## **BASFORD SUBDIVISION**

The plat illustrates the proposed 2-lot, 0.92± acre subdivision which is located on the Southeast corner of Howells Ferry Road and Dover Street within Council District 7. The applicant states that the subdivision is served by city water and sanitary sewer systems.

APPLICATION NUMBER 4 DATE April 7, 2016

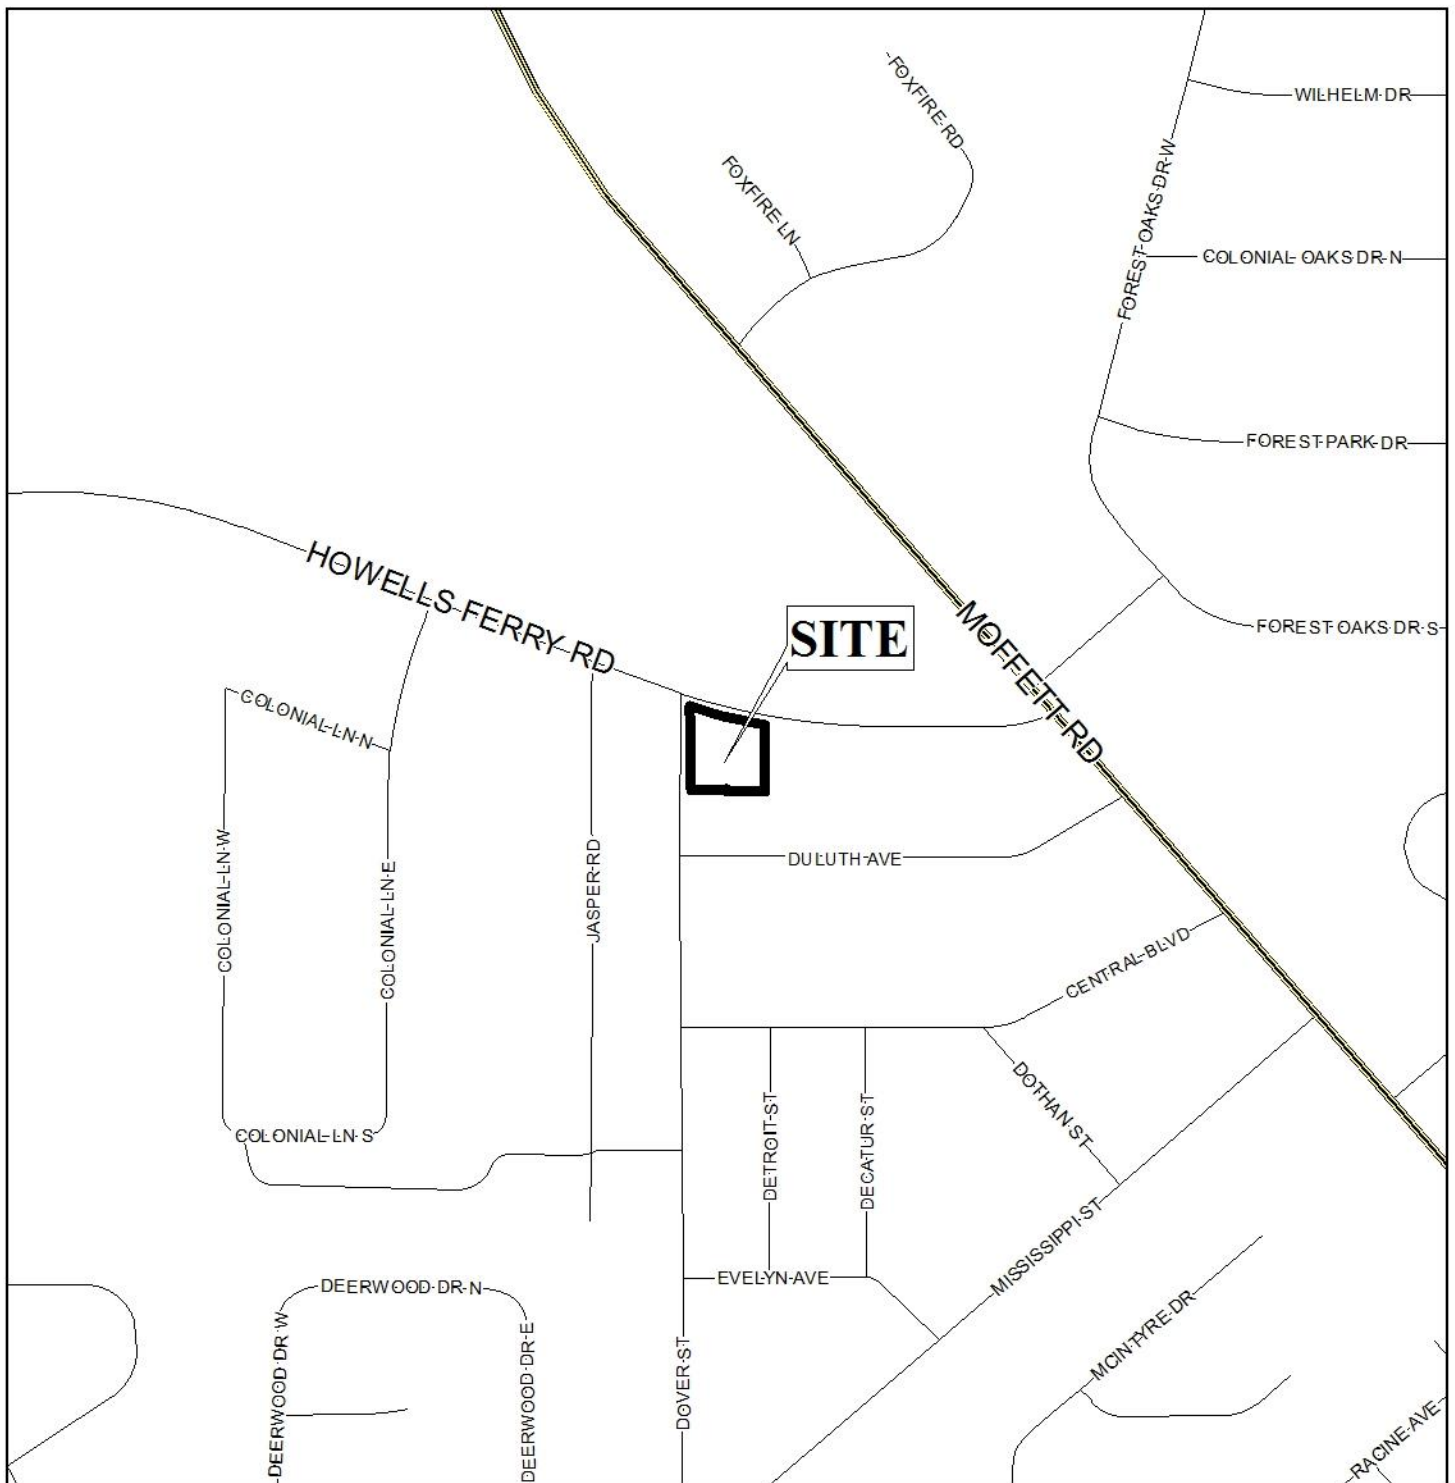
The proposed lots front both Howells Ferry Road and Dover Street. Howells Ferry Road is a minor street, without curb and gutter, which requires a 60' right-of-way width. Dover Street is a minor street, with curb and gutter, and requires a right-of-way width of 50'. The Final Plat, if approved, should be revised to reflect dedication sufficient to provide 30' from the centerline of Howells Ferry Road.

Being that the subject site has frontage along both Howells Ferry Road and Dover Street, the applicant must ensure that the property lines at this intersection provide a compliant curb radius in compliance with Section V.D.6. of the Subdivision Regulations. The curbed radius is depicted on the preliminary plat and should be retained on the Final Plat, if approved.

The preliminary plat depicts side and rear yard setbacks: the Subdivision Regulations only require depiction of setbacks from the right-of-way. The Zoning Ordinance; however, does require rear and side yard setbacks. If the applicant wishes to show side and rear yard setbacks which meet Zoning Ordinance requirements, then side yard setbacks for Lot 2 should be revised on the Final Plat, if approved, so that the sum of both side yards equal 20' and not 16' as indicated on the preliminary plat.

A 25-foot minimum building setback line is depicted on the preliminary plat along both Howells Ferry Road and Dover Street and, if approved, should be retained on the Final Plat, adjusted for any required dedication along Howells Ferry Road.

In accordance with Section V.D.2. of the Subdivision Regulations, the proposed lot appears to exceed the 7,200 square foot minimum lot size requirements for lots served by public water and sanitary sewer systems. The lot size information is depicted in both square feet and in acres on the preliminary plat and should be retained on the Final Plat, if approved, adjusted for any required dedication.

As a means of access management, a note should be placed on the Final Plat, if approved, stating that the proposed Lot 1 is limited to one curb cut to Dover Street and that the proposed Lot 2 is limited to the existing curb-cut to Howells Ferry Road, with the size, design and location of any new or existing curb-cuts to be approved by Traffic Engineering and conform to AASHTO standards.

- 1) Dedication sufficient to provide 30' from the centerline of Howells Ferry Road;
- 2) Retention of the dimensioned curb radius at the intersection of Howells Ferry Road and Dover Street;

- 3) Revision of the side yard setbacks for Lot 2 so that the sum of both side yards equal 20', if the applicant chooses to depict Zoning Ordinance compliant side yards;

- 4) Retention of the 25' minimum building setback line along Howells Ferry Road and Dover Street, adjusted for dedication;
- 5) Retention of the lot size information on the Final Plat, adjusted for dedication;

- 6) Placement of a note on the Final Plat stating that the proposed Lot 1 is limited to one curb cut to Dover Street and that the proposed Lot 2 is limited to the existing curb-cut to Howells Ferry Road, with the size, design and location of any new or existing curb-cuts to be approved by Traffic Engineering and conform to AASHTO standards.;;
